ADDENDUM NO. 5

REGIONAL PARK RESTROOMS
PROJECT NUMBER 122013

The following revisions to the Plans shall be made:

1 LAYOUT INDEX PLAN (RAHILLY PARK)
SCALE: 1" = 20'

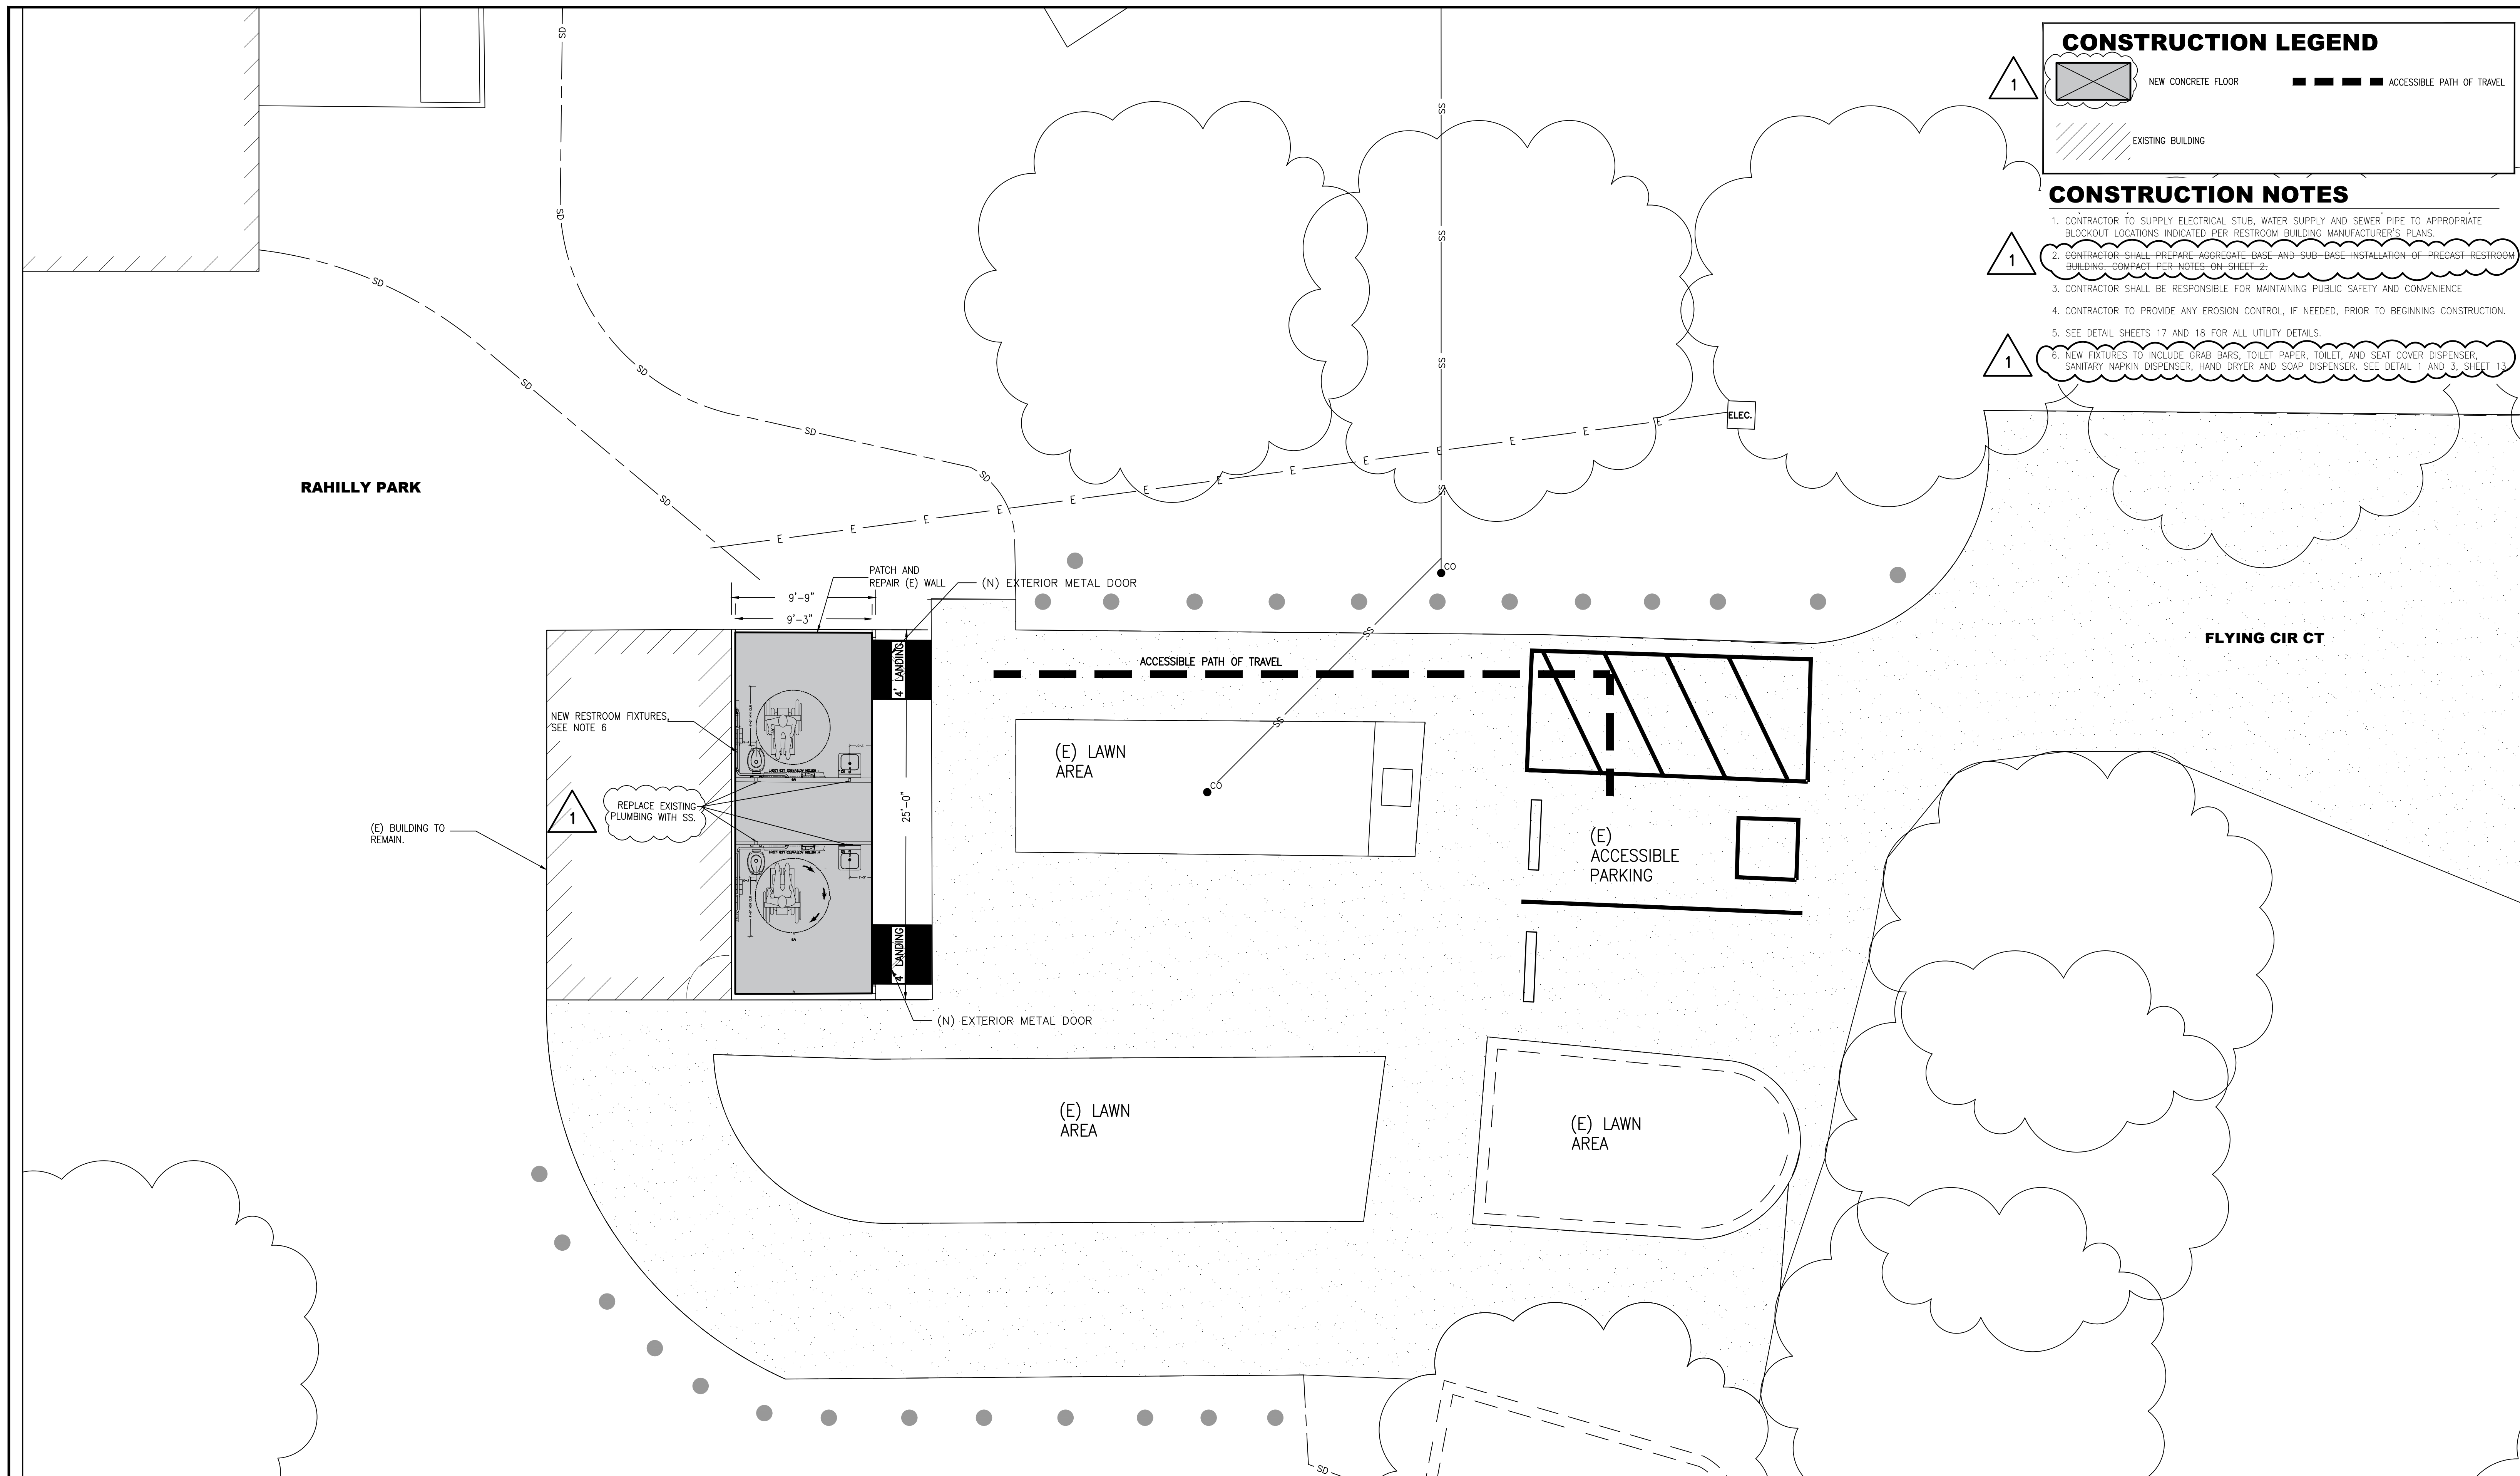
NO.	DATE	BY	REVISION MADE
1	2/15/2023	VM	New concrete flooring item deleted
2	2/15/2023	VM	Remove construction note #2. Not needed.
3	2/15/2023	VM	Added plumbing to be replaced with SS.
4	2/15/2023	VM	Added toilet to construction note #6 and changed sheet #.

1 TOPOGRAPHIC SURVEY, DEMO AND CONSTRUCTION PLAN
SCALE: 1" = 10'

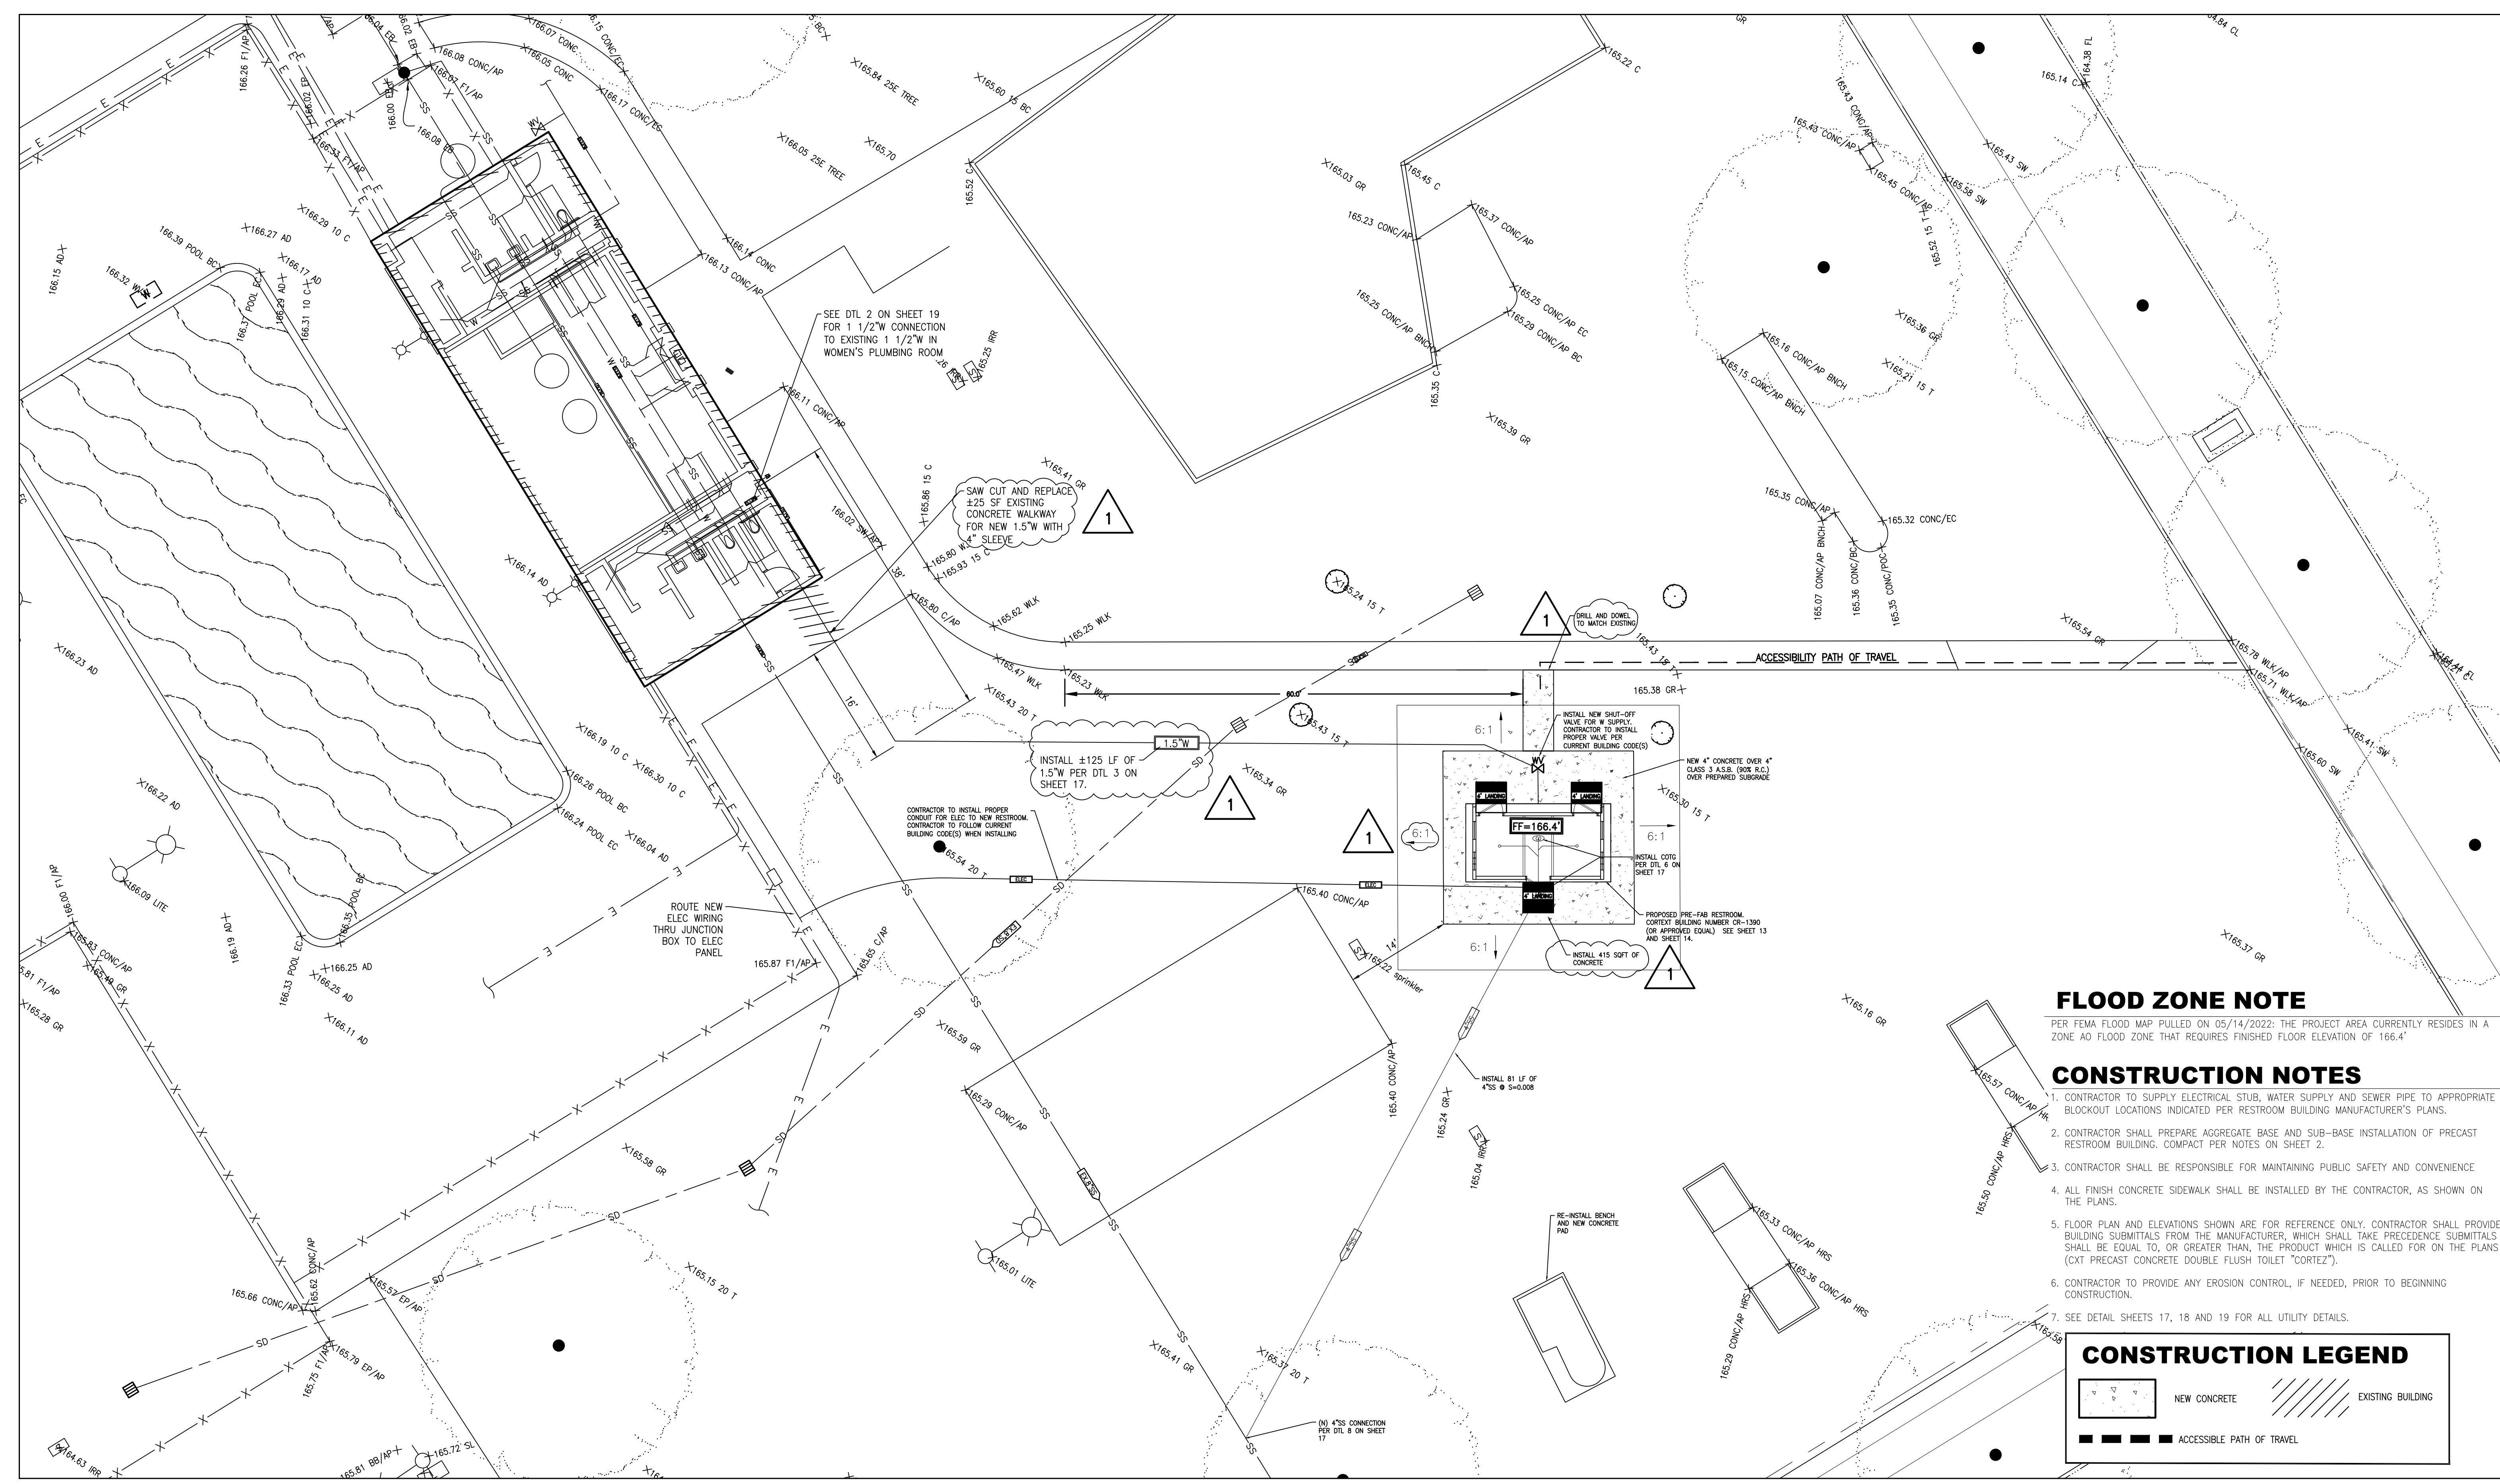
NO.	DATE	BY	REVISION MADE
1	2/15/2023	VM	Change from bore to saw and remove/replace sidewalk.
2	2/15/2023	VM	Change water line to 1.5" and detail call out number.
3	2/15/2023	VM	Drill and dowel into sidewalk added.
4	2/15/2023	VM	Changed SQFT of concrete from 513 to 415.
5	2/28/2023	VM	Native fill required to raise pad 1' and create 6:1 slopes.

1 ENLARGED TOPOGRAPHIC SURVEY, DEMOLITION AND CONSTRUCTION PLAN
SCALE: 1" = 10'

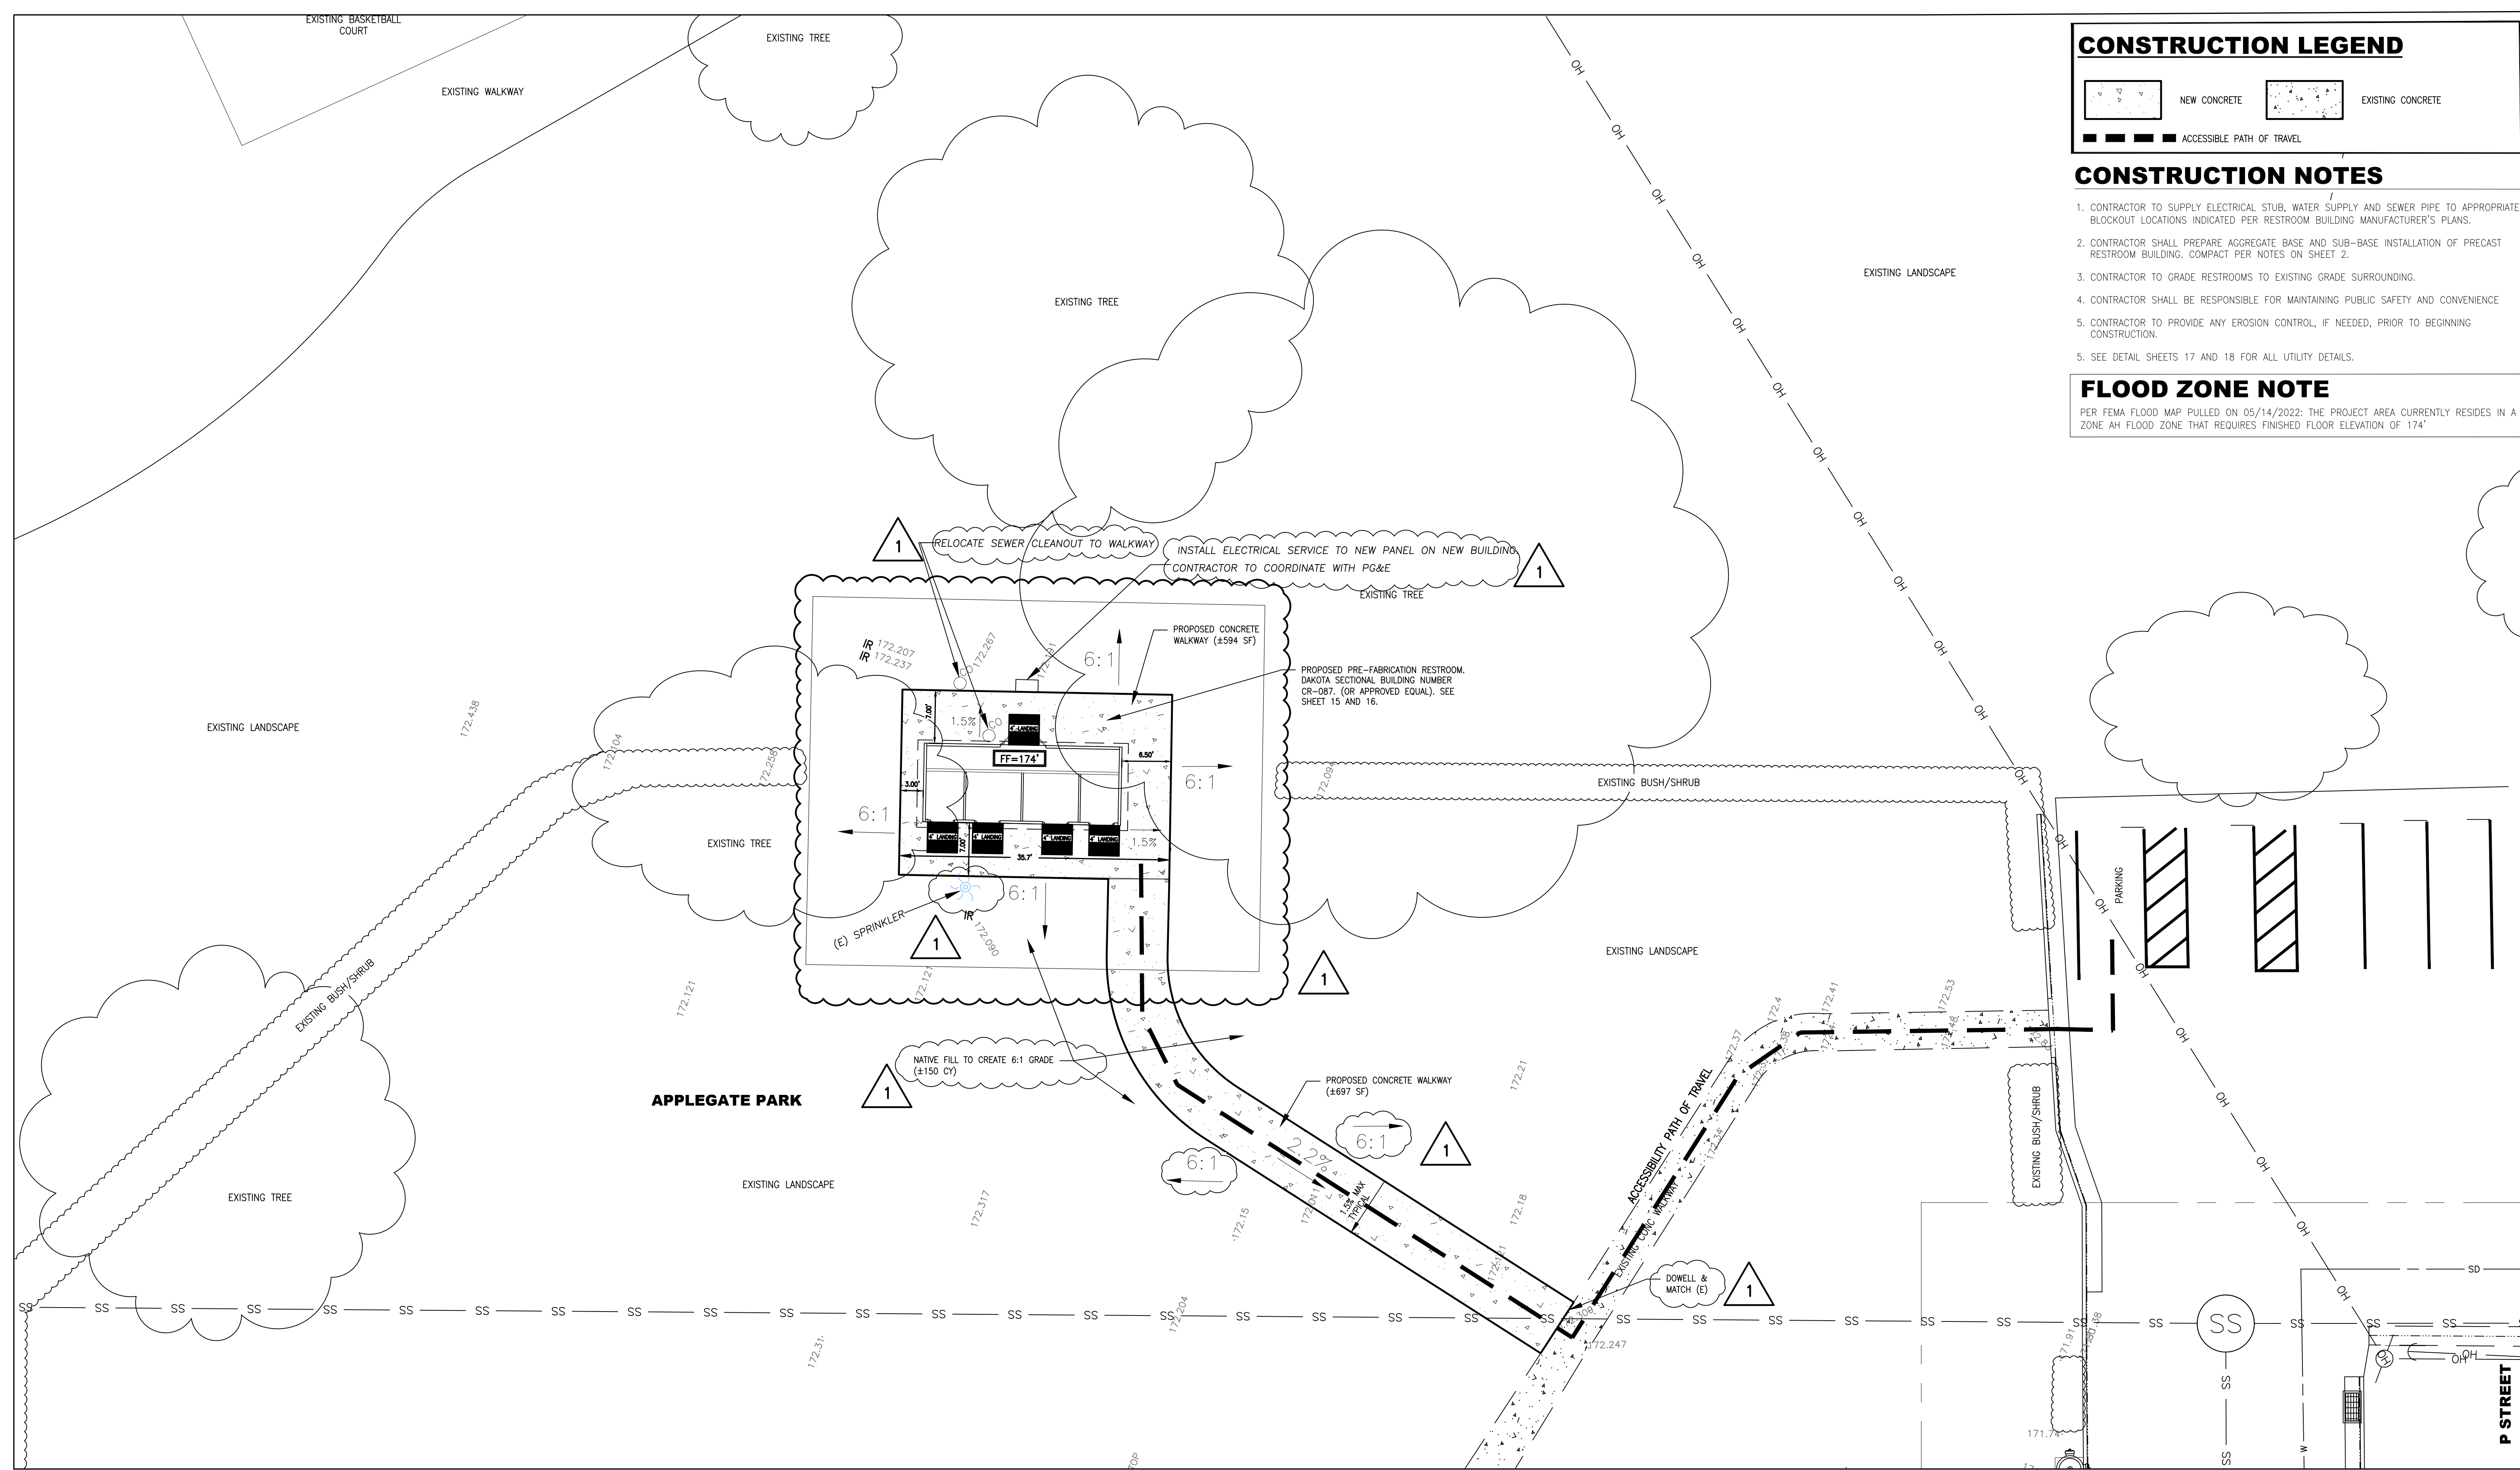
NO.	DATE	BY	REVISION MADE
1	2/15/2023	VM	Grade sides of concrete pad to blend into existing ground 6:1
2	2/22/2023	VM	Grade sides along walkway to blend into existing ground 6:1
3	2/22/2023	VM	Raise sprinkler to grade
4	2/22/2023	VM	Dowell new walkway to existing walkway
5	2/22/2023	VM	Native fill required to raise pad 2' and create 6:1 slopes.
6	2/22/2023	VM	Relocate sewer cleanout to concrete walkway
7	2/22/2023	VM	Install electrical service to new restroom w/PG&E coordination
8	2/22/2023	VM	Raise irrigation to match new grade
